Subject: RE: Marshall & Winston Loco Dinero 1RP-5069

Marshall & Winston, Inc. Loco Dinero 36 State 2H OCD Case Number 1RP-5069

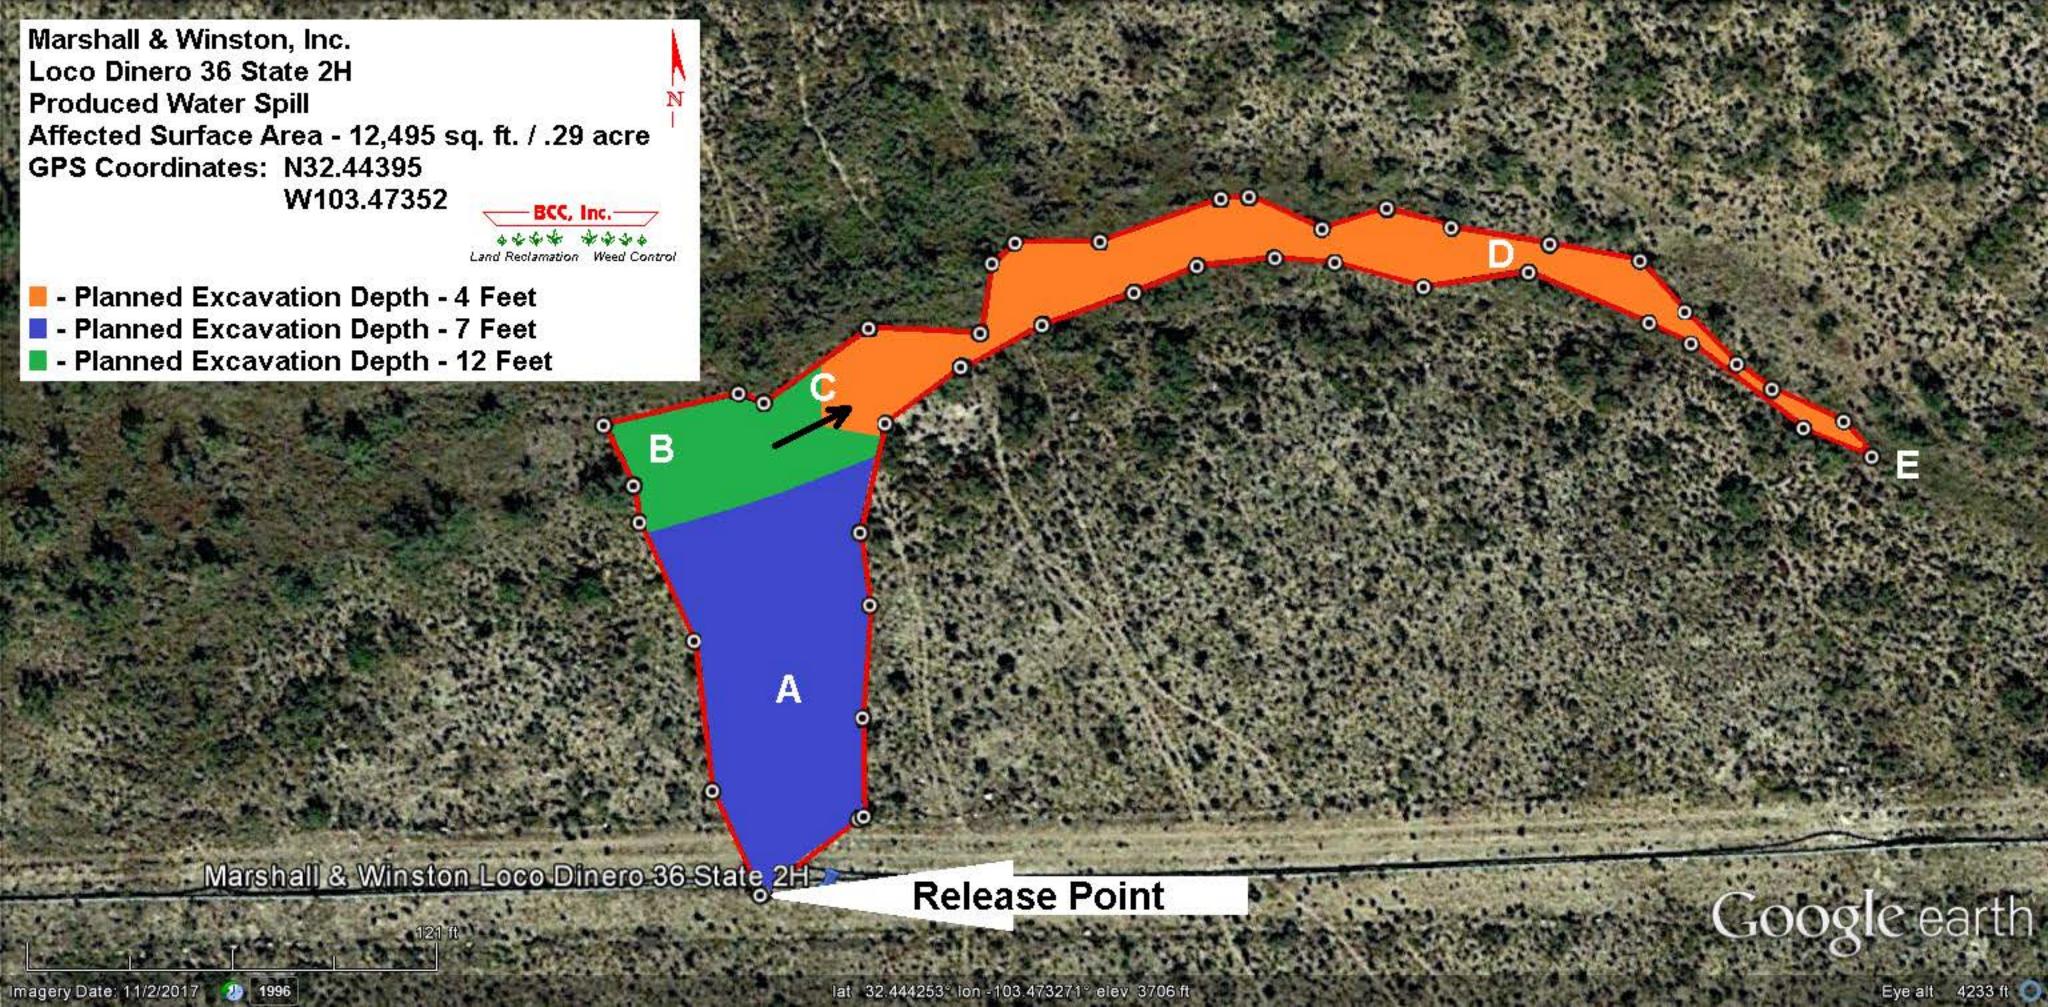
- 1. Collect a soil sample at the release point and submit for Benzene, BTEX and TPH extended laboratory analyses.
- 2. As the chloride delineation data for sample location C were above permissible levels and is in the vicinity of the edge between 4 ft. (orange) and 12 ft. (green) areas, at least one confirmation sample needs to be collected from this wall.

- 1. Were soil samples tested for Benzene, BTEX, or TPH extended at any stage?
- 2. What is the rationale for excavation greater than 4 ft. bgs? Please provide field test data for the depths that were not sent for laboratory analyses.
- 3. Were there sidewall samples taken between the different depths of excavation? For example, at the border between the 4 ft. and 8 ft. excavation areas?

Good to hear back from you. This spill was entirely a produced water spill, so I did not have any TPH, BTEX, or Benzene samples laboratory tested. When the spill initially happened, I did run field TPH tests on several areas throughout the affected pasture and I will provide the field test data to you (there were no hydrocarbons detected at all). The reason we had to excavate greater than 4 ft. bgs was due to Bradley Blevins (ranch foreman) with Merchant Livestock Co. He insisted on 100% of the contaminated soils were to be excavated and replaced (he said that this was 'Fee' land where the release occurred). I had previously sent in our initial field test data to you for the various depths tested during delineation and I have attached that information back to this email for your review. The sidewall samples were field tested for chlorides with one near the top and one at the bottom in the sidewall. The laboratory analysis that I sent to you was from the sidewall samples being pulled directly in the center for the average after all samples during field testing were below the 600 ppm threshold on this last time. Thank you Olivia!
